#### SCHEDULE OF CHANGES

Rev.	Date	By	Ckd	Description
G	17/08/2023	WN	DN	S4.56 Issue 2

30 Fairlight St, Fairlight  
30 Fairlight St,  
Fairlight, NSW 2094

Section - S-02

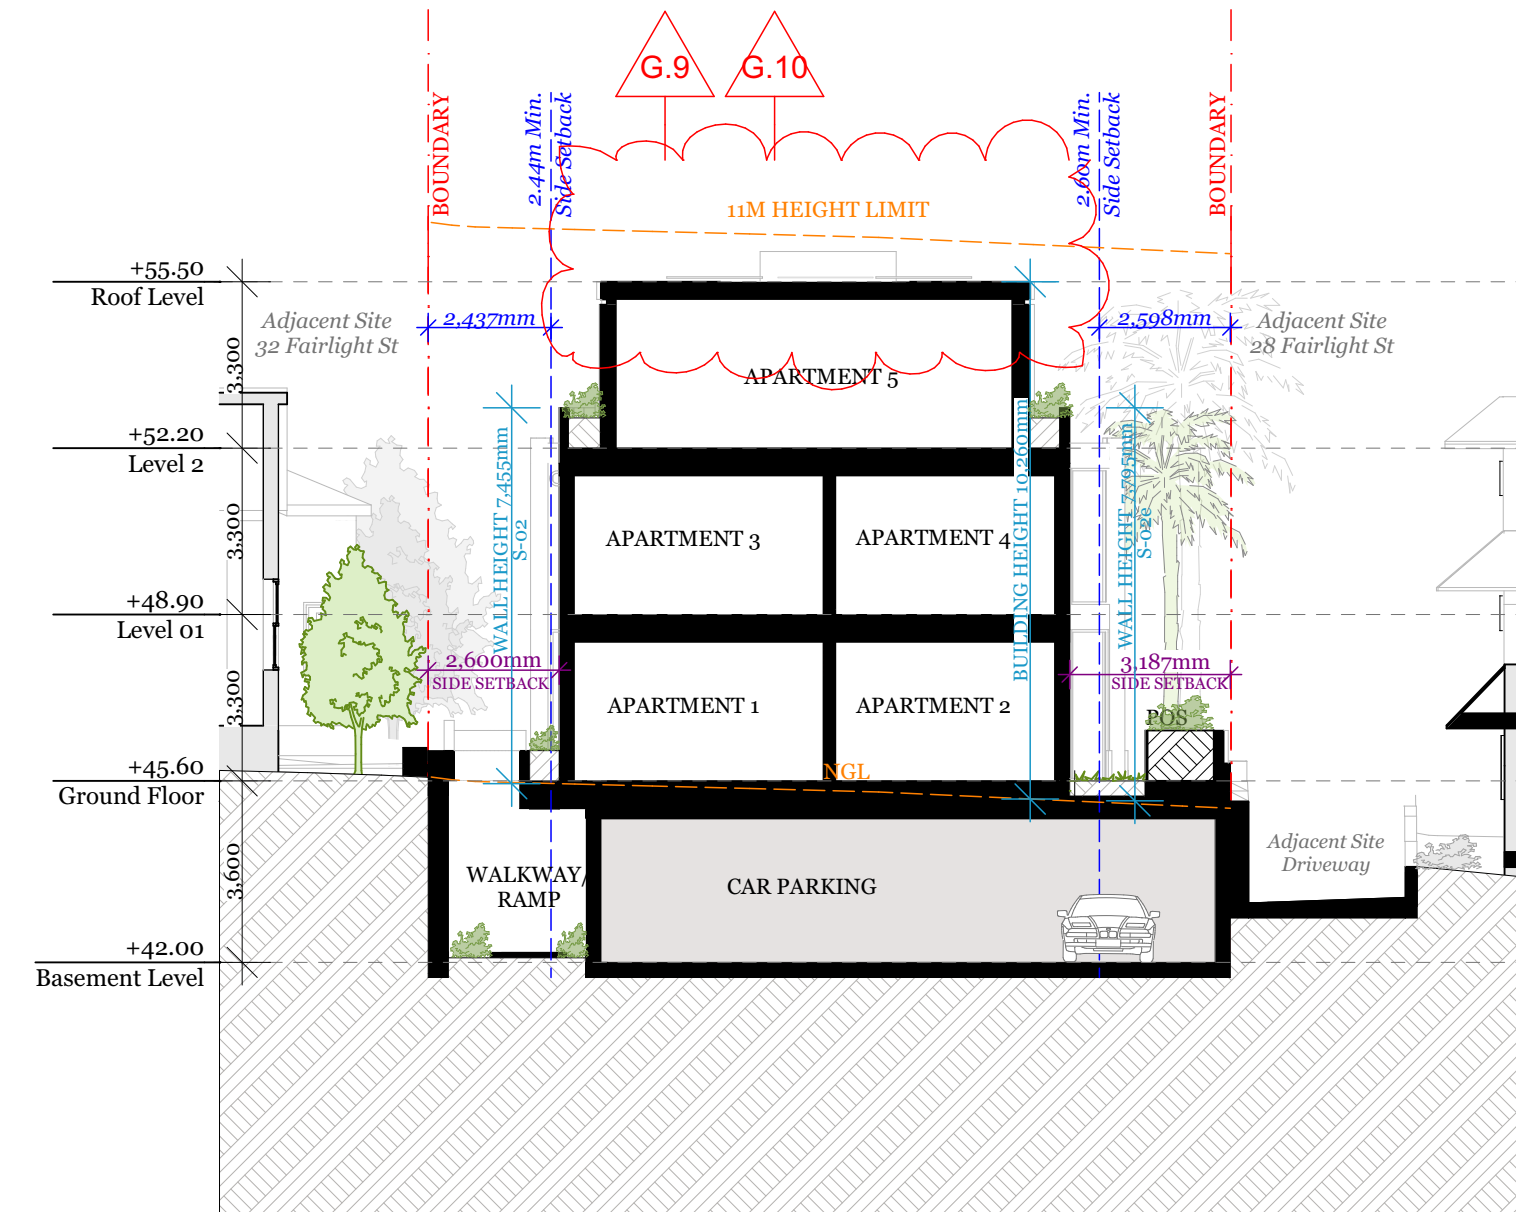
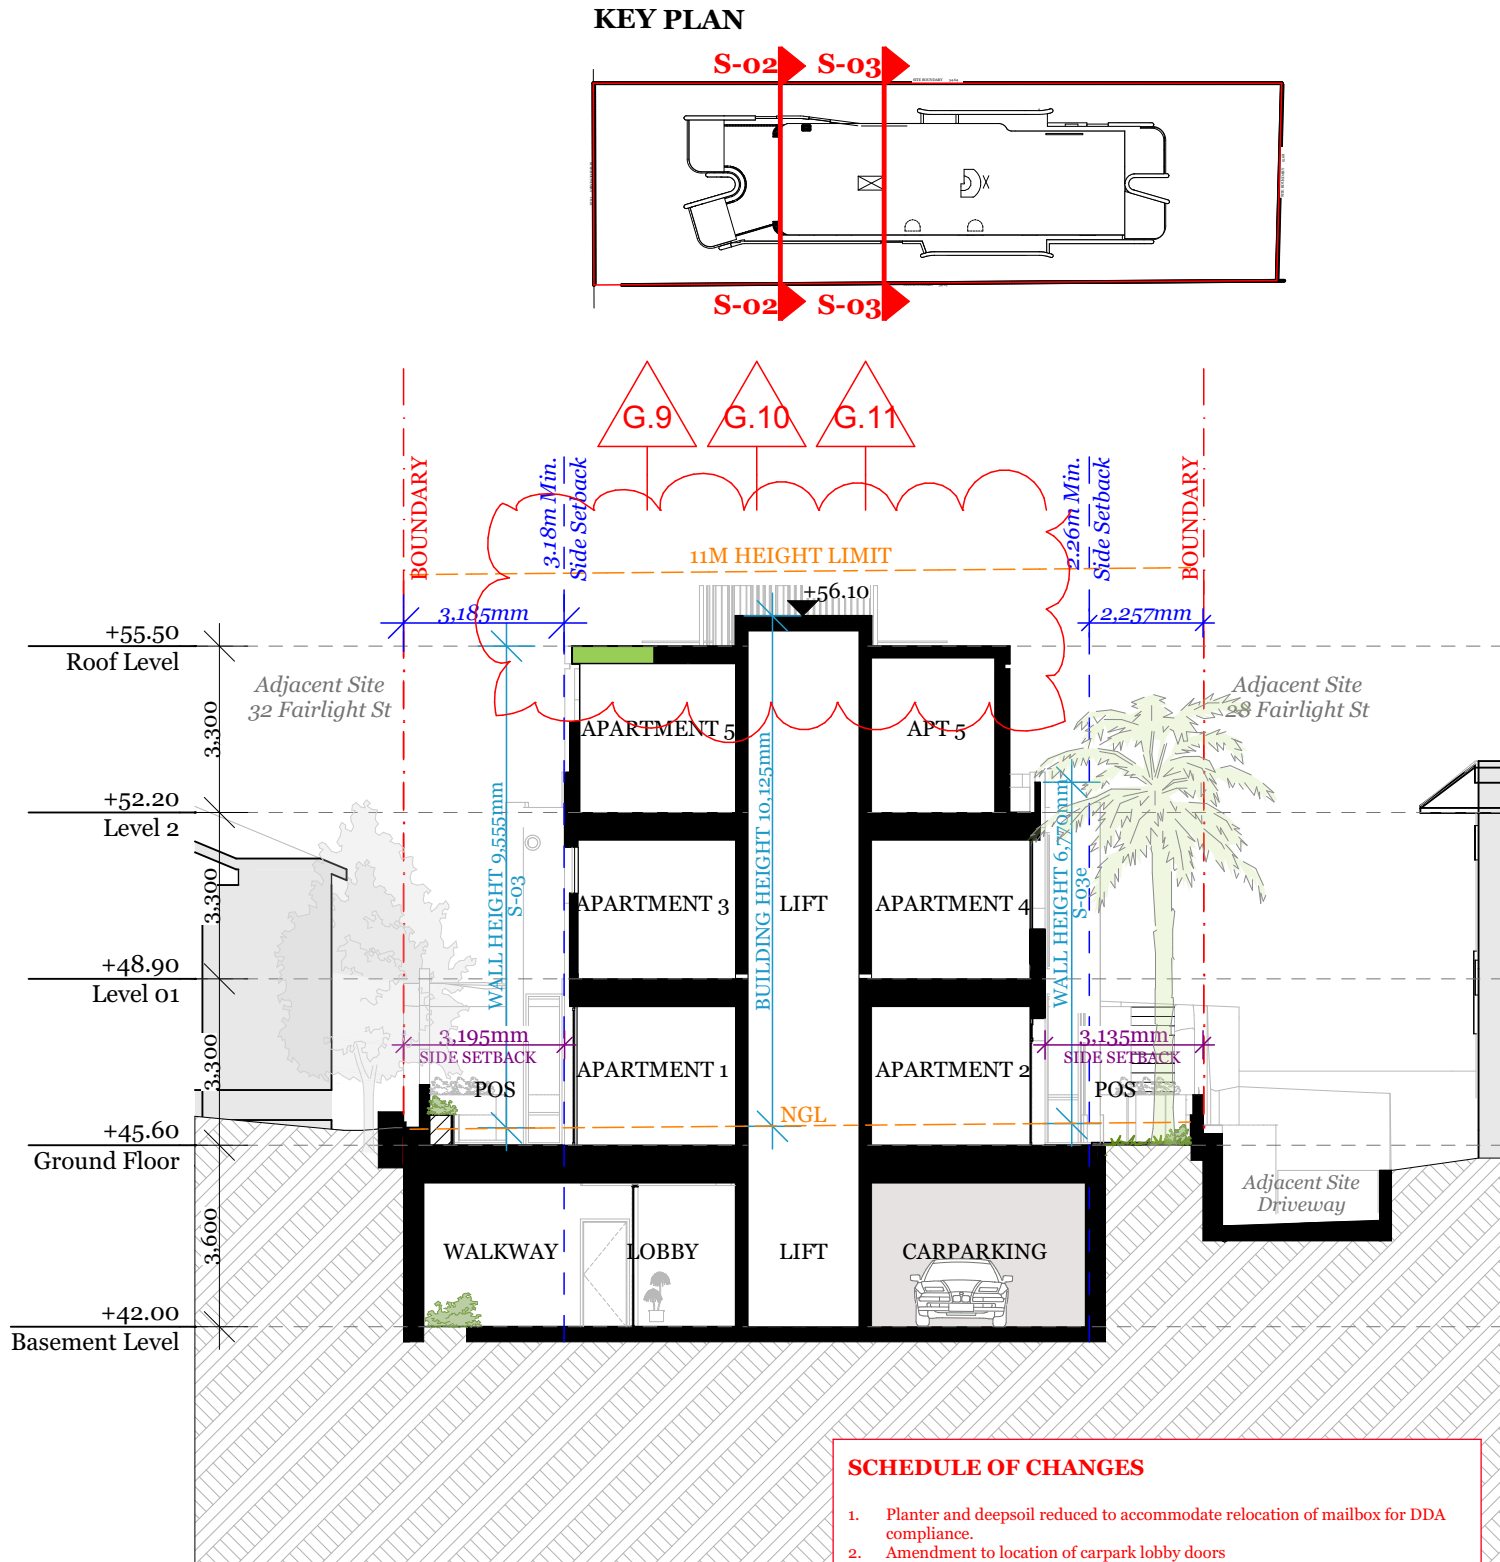
SCHEDULE OF CHANGES	
1.	Planter and deepsoil reduced to accommodate relocation of mailbox for DDA compliance.
2.	Amendment to location of carpark lobby doors
3.	OSD tank extended to accommodate minimum volume as per Stormwater Engineer's report.
4.	Additional door added for compliance as alternate fire egress with NCC D2D6.
5.	Landscaping and planter replaced with terrace hardscape to accommodate OSD tank volume below.
6.	Wall of front terrace rationalised for buildability
7.	Window opening reconfigured.
8.	Internal layout reconfigured and rationalised
9.	Plant services added onto roof including AC condensers, hot water units and mechanical vent exhausts to be concealed with metal screen enclosure
10.	PV panels added.
11.	Skylights deleted.
12.	Solid access hatch cover amended to glazed hatch.
13.	Courtyard landscape amendment.

Project Name	30 Fairlight St, Fairlight	Project Number	00012781
Project Address	30 Fairlight St, Fairlight, NSW 2094	Drawing Name	Sections - Sheet 3
		Scale	1:1 (A3)
		Date	August 2023
Client	Adjani Pty Ltd	Drawing Number	DA402
		Revision	G

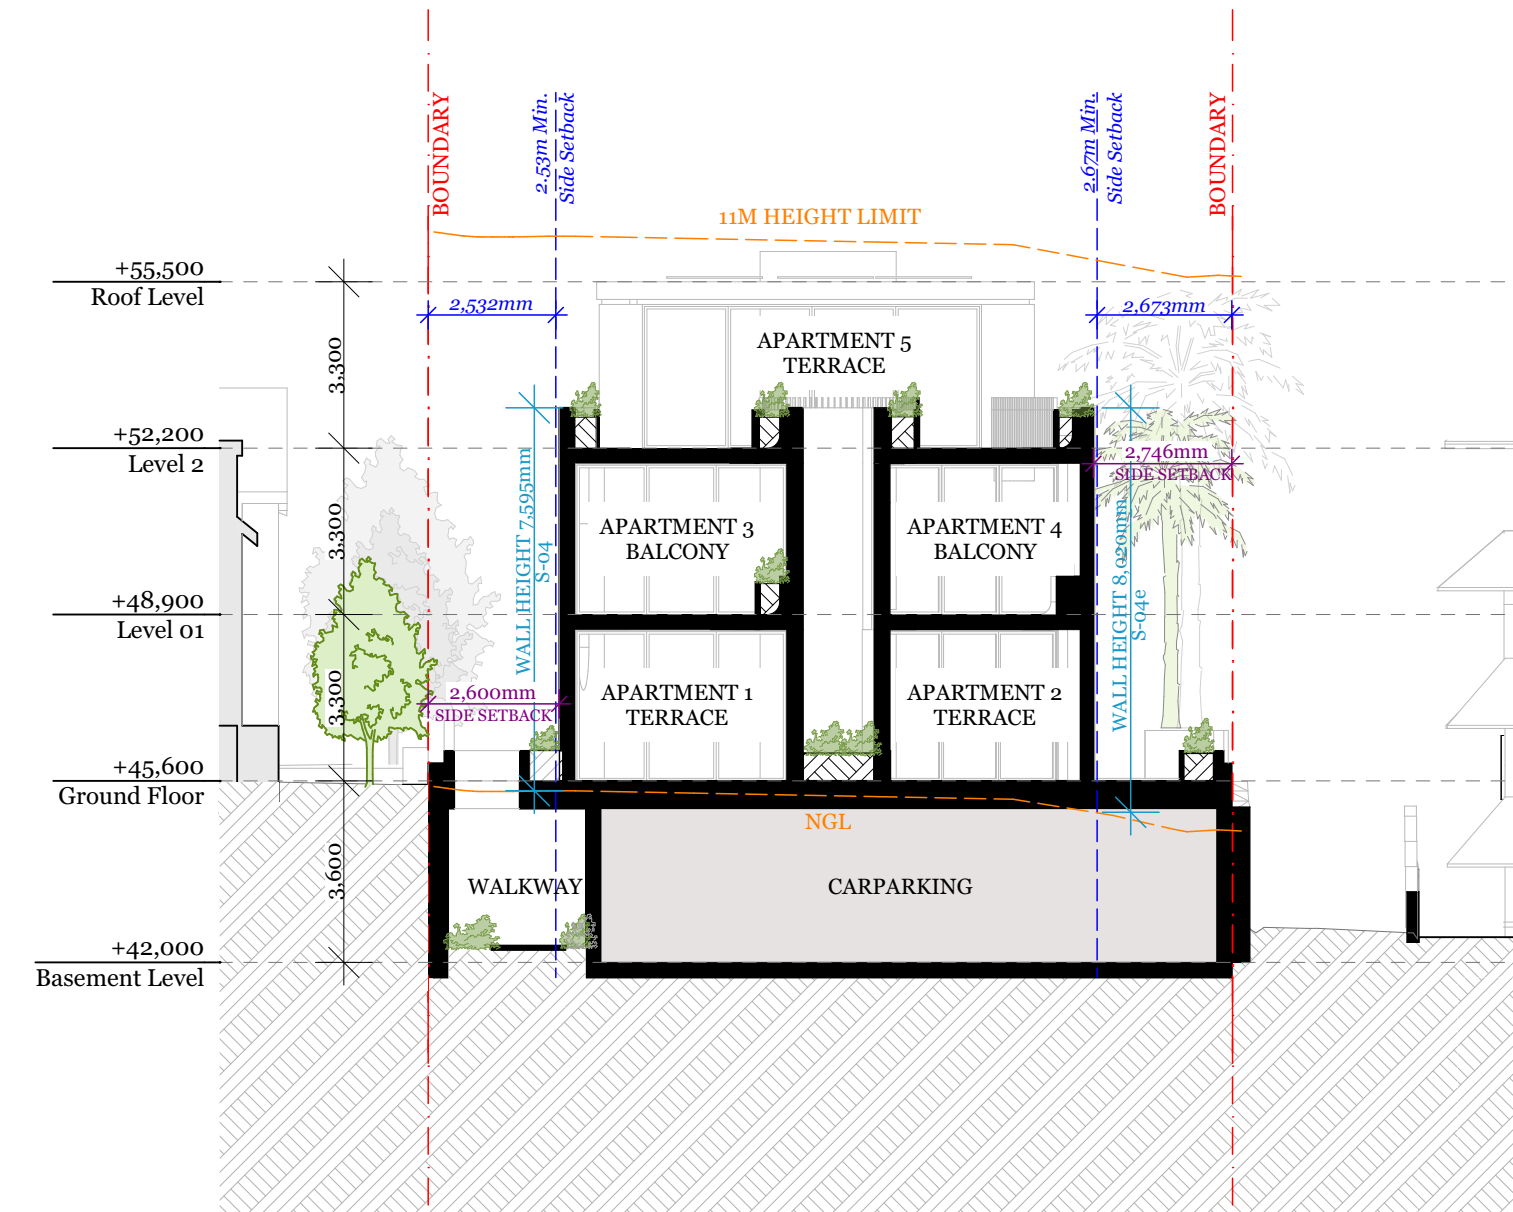
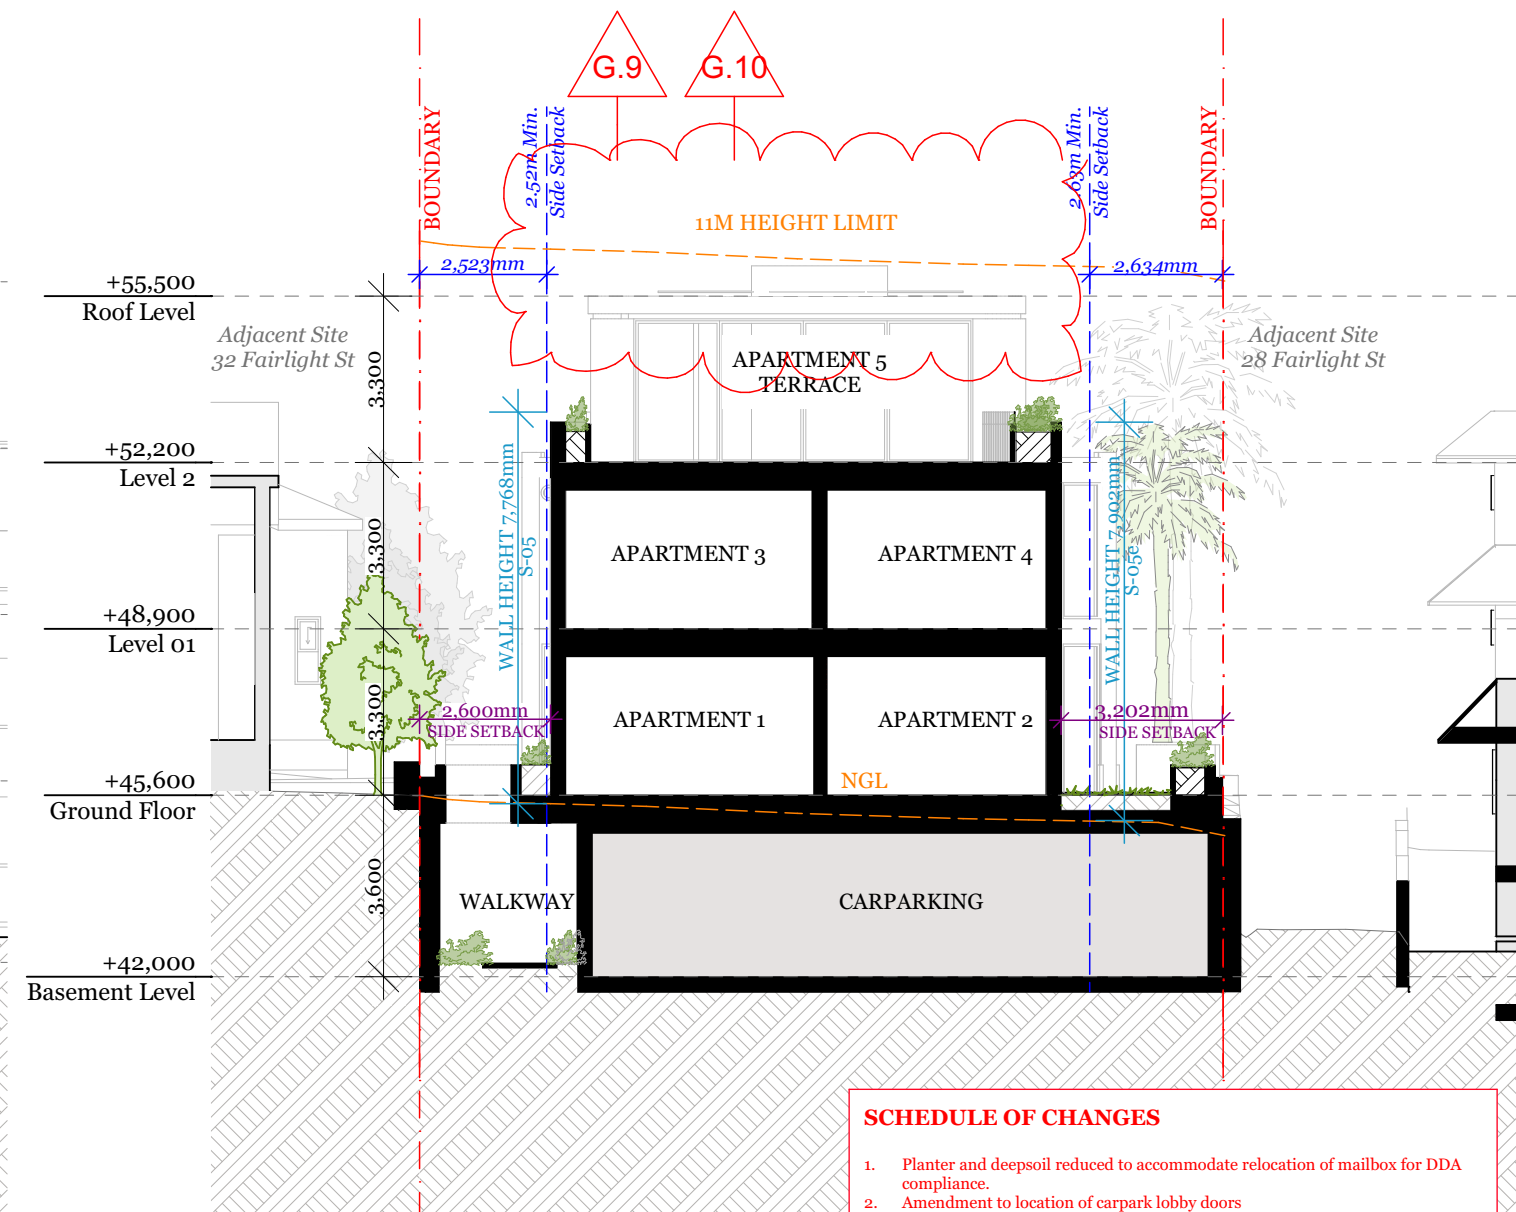
SCHEDULE OF CHANGES	
1.	Planter and deepsoil reduced to accommodate relocation of mailbox for DDA compliance.
2.	Amendment to location of carpark lobby doors
3.	OSD tank extended to accommodate minimum volume as per Stormwater Engineer's report.
4.	Additional door added for compliance as alternate fire egress with NCC D2D6.
5.	Landscaping and planter replaced with terrace hardscape to accommodate OSD tank volume below.
6.	Wall of front terrace rationalised for buildability
7.	Window opening reconfigured.
8.	Internal layout reconfigured and rationalised
9.	Plant services added onto roof including AC condensers, hot water units and mechanical vent exhausts to be concealed with metal screen enclosure
10.	PV panels added.
11.	Skylights deleted.
12.	Solid access hatch cover amended to glazed hatch.
13.	Courtyard landscape amendment.
